DATE: December 12, 2023
PAGE: 1 of 62 (INCLUDING THIS PAGE)
TO: ALL CONTRACTORS
FROM: Craig Sanford
PROJECT: INTEGRITY PARK PHASE II
FOR THE CITY OF SPANISH FORT
GMC PROJECT NO. CMOB230047
RE: ADDENDUM #1

ADDENDUM NUMBER 1

INTEGRITY PARK PHASE II

SITE PLAN
C-101

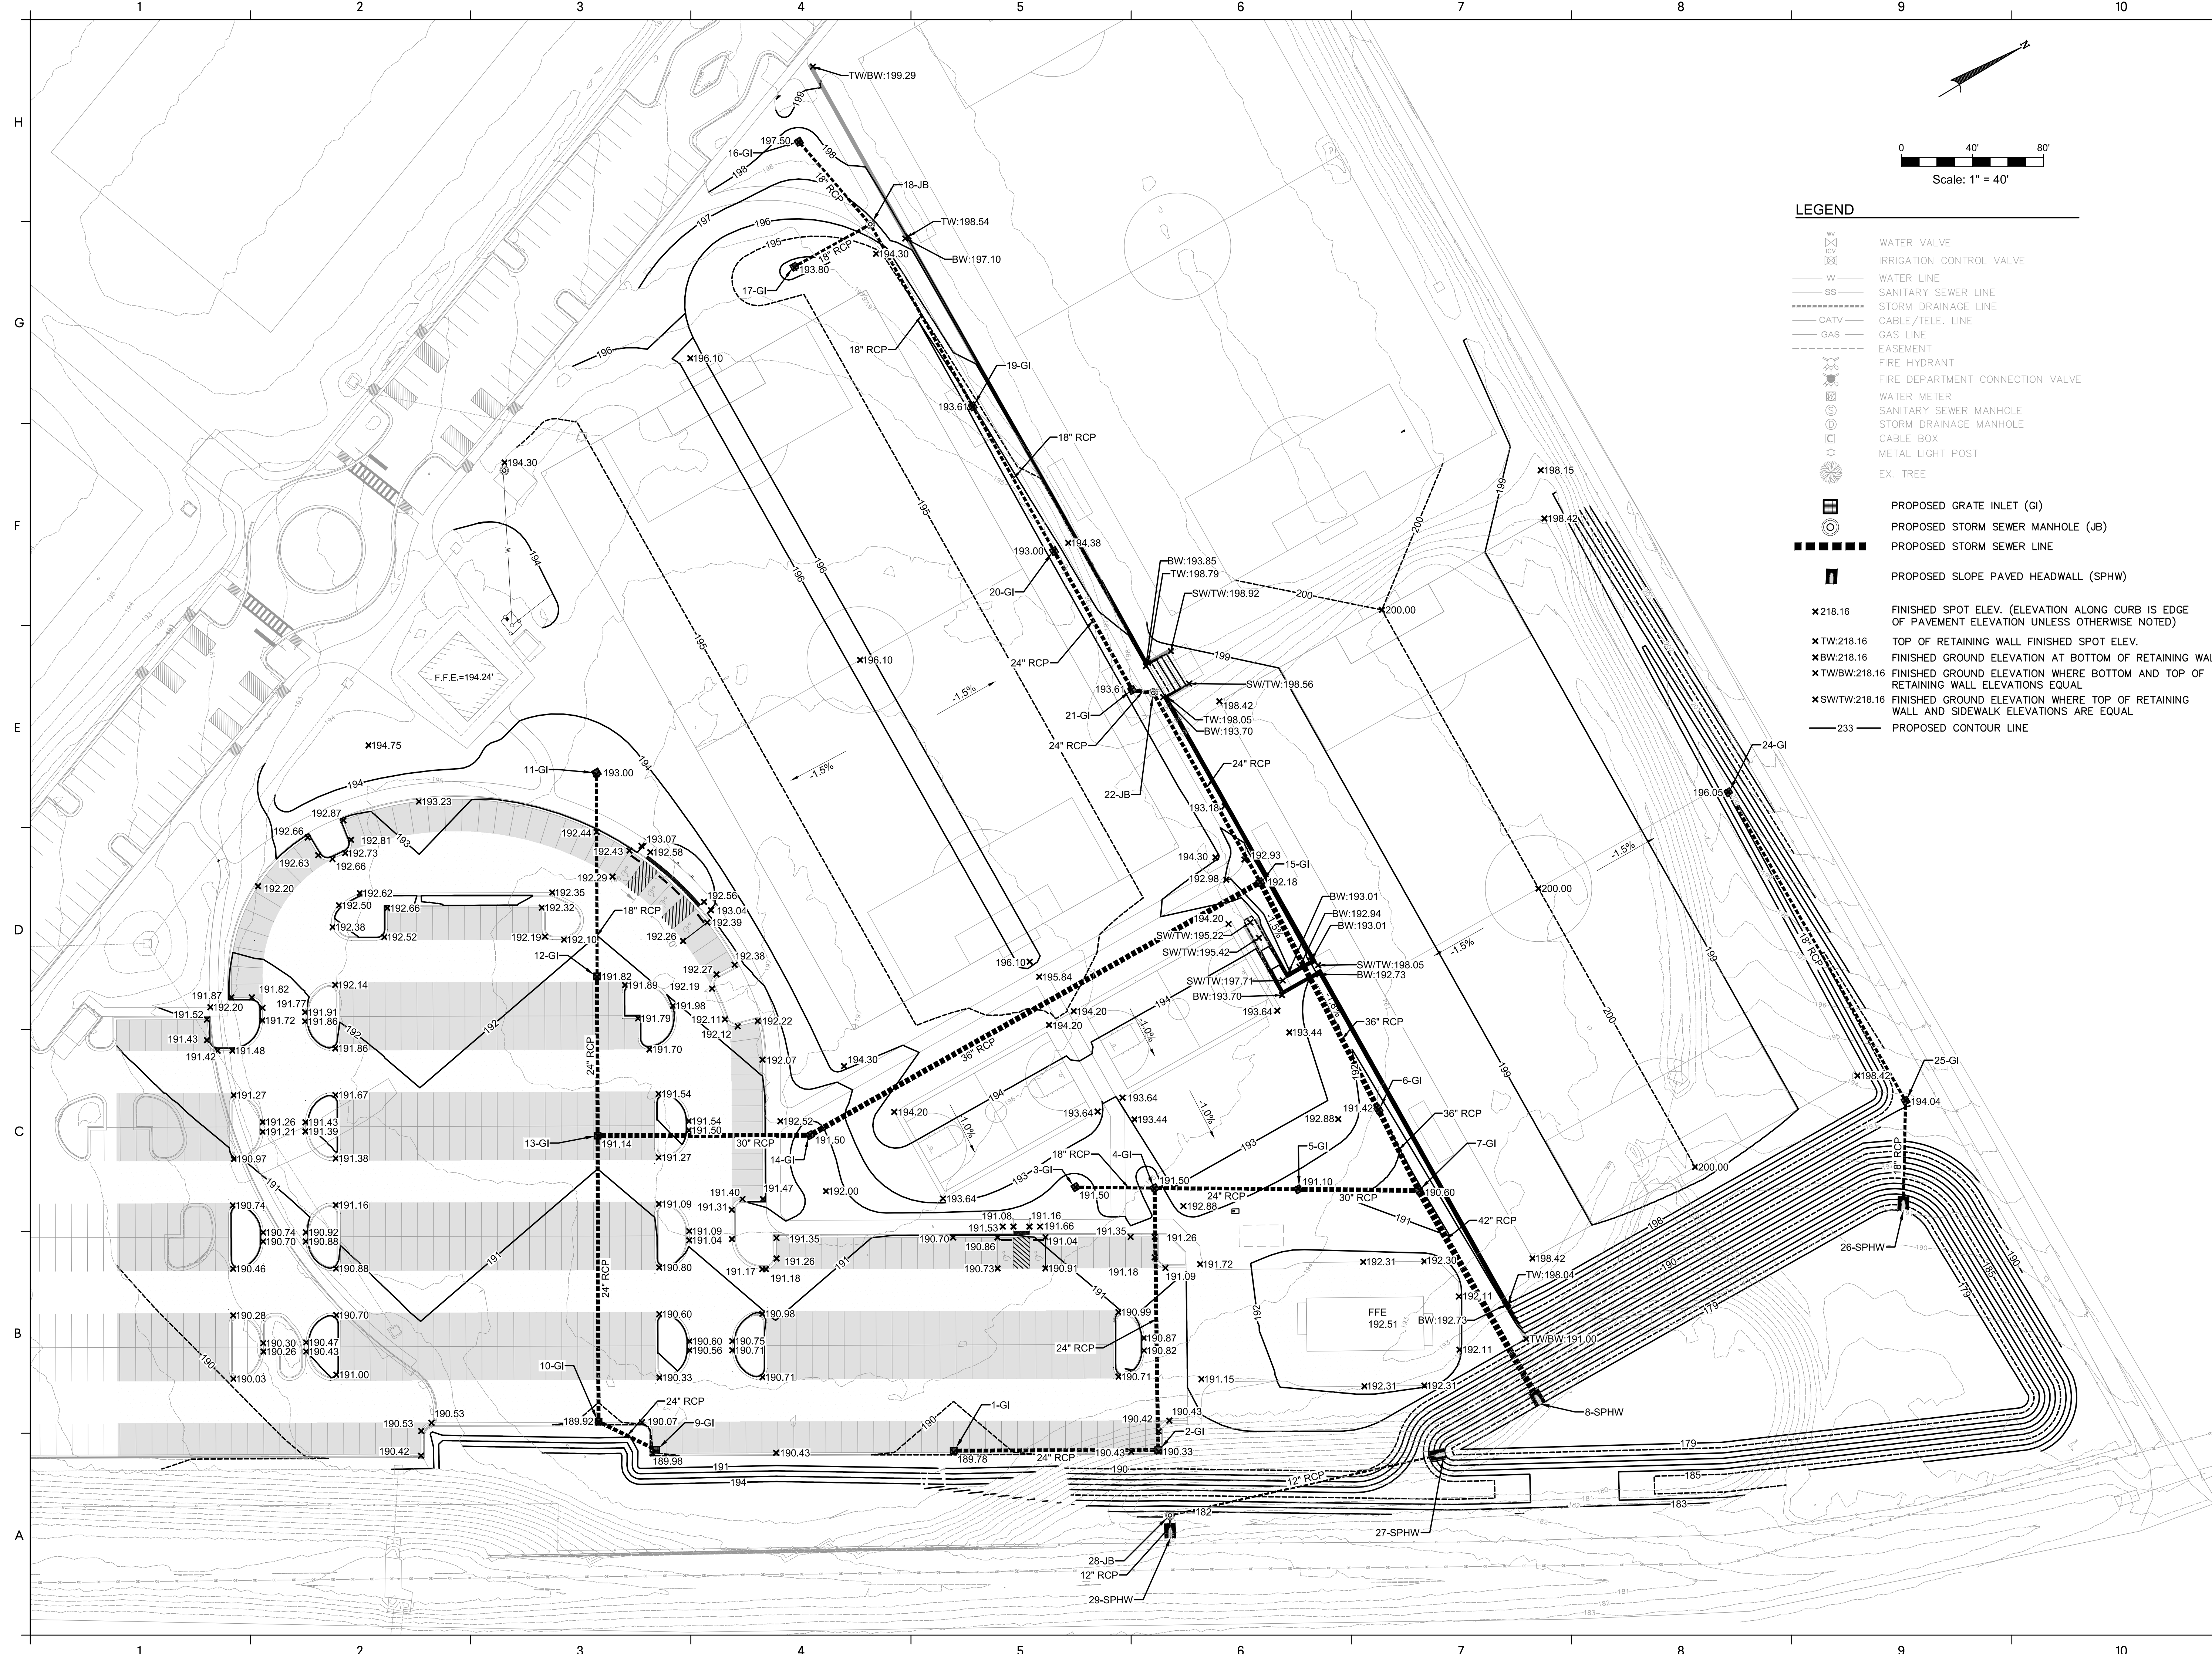
- 4.1 **On Sheet C-101, it calls out for fencing on the retaining wall, what type of fence is going there and what would the height be? If it is chain link, would they want it to be core drilled or flange mounted?**
All chain link fencing shall match detail 6 as shown on sheet SF4.00. See Site Note 15 on Sheet C-001 of Revised Plan Set from December 7, 2023 regarding the retaining wall. The system utilized for the installation of the fence shall be approved by the retaining wall manufacturer.
